# UNITED STATES PATENT AND TRADEMARK OFFICE

APPLICATION NO.	FILING DATE	FIRST NAMED INVENTOR	ATTORNEY DOCKET NO.	CONFIRMATION NO.
10/710,253	06/29/2004	Rolf Hohmann	27475/05337	4252-
24024	7590	04/26/2007	EXAMINER	
CALFEE HALTER & GRISWOLD, LLP			MITCHELL, KATHERINE W	
800 SUPERIOR AVENUE			ART UNIT	PAPER NUMBER
SUITE 1400				
CLEVELAND, OH 44114			3677

<b>Office Action Summary</b>	<b>Application No.</b>	<b>Applicant(s)</b>	
	10/710,253	HOHMANN ET AL.	
	<b>Examiner</b>	<b>Art Unit</b>	
	Katherine W. Mitchell	3677

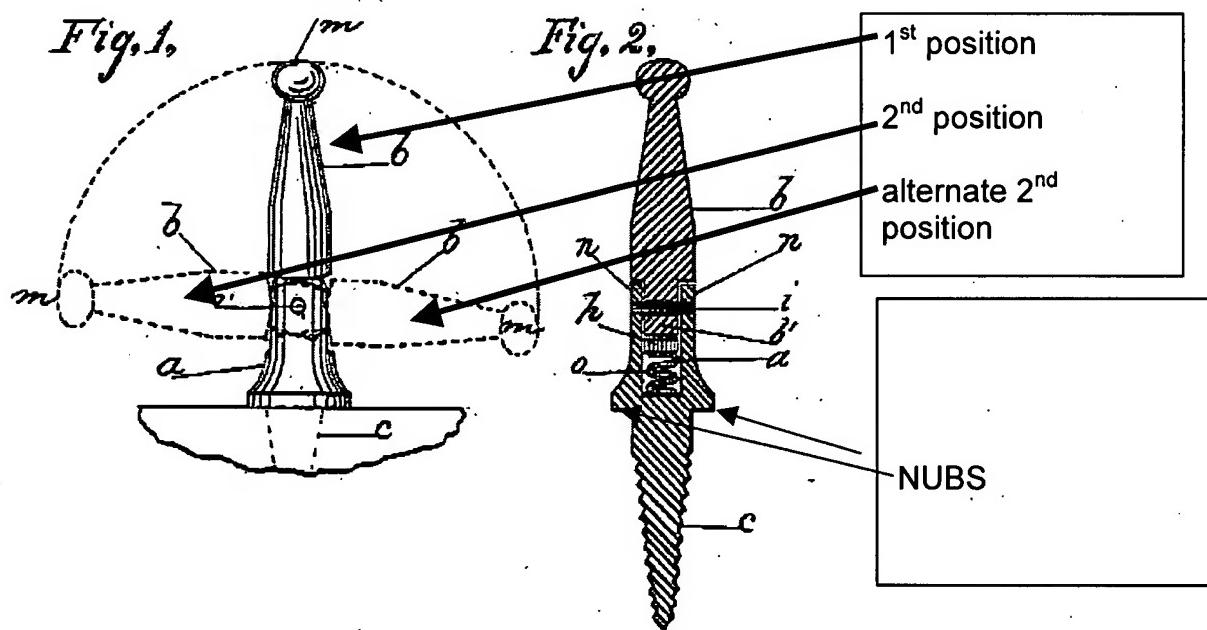
5. Claims 12-13,18,24,26,30,31 are rejected under 35 U.S.C. 102(b) as being anticipated by Votaw, USP 370028.

Re claims 12 and 30: Shaft is "a", locking member is "b". First (solid line version of "b" in Fig 1) and second (dotted line version of "b" in Fig 1 above) positions are as indicated in Fig 1 and described above.

Spring "o" and plate "h" serve as retention means for either the 1<sup>st</sup> or 2<sup>nd</sup> position.

Note that the slot is considered the lengthwise recess -- "that portion below the base of the jaws is bored out or recessed lengthwise to receive a spring "o"..." The at least one cut out portion on an outer surface and disposed along a slot is the center cut-out portion between jaws "n", which is sized to receive locking member b in seating engagement and retain the locking member in the second (no removal, dotted lines of b) position.

FURTHER RE claim 30: The locking member extends laterally from only one side of the shaft per Fig 1. Note however, it can extend in either of 2 locking positions.

Re claim 13: "C" is considered the angled end portion located at second end of shaft member-- Fig 2.

Re claim 18: Nubs are labeled in Fig 2 above.

Re claim 24: 1<sup>st</sup> and 2<sup>nd</sup> cut out portions 90 degrees apart are considered the openings between the jaws n. Note that the center cut out portion between jaws can be considered 3 cut out portions -- a portion on the "top plane" through which locking member extends when in the 1<sup>st</sup> position, and a cut out between the jaws on the left side through which locking member extends when in the 2<sup>nd</sup> position and a portion between the jaws on the right side of the shaft through which locking member extends

when in the alternate 2<sup>nd</sup> position. These 3 cut out portions form the center cut out portion described by Votaw.

Re claims 26 and 31: The locking member b is adapted to be pulled out of engagement with the at least one cut out to allow the locking member to be rotated from the 1<sup>st</sup> to the 2<sup>nd</sup> position. Spring force will require at least some degree of pulling out to rotate the locking member from 2<sup>nd</sup> to 1<sup>st</sup> position.
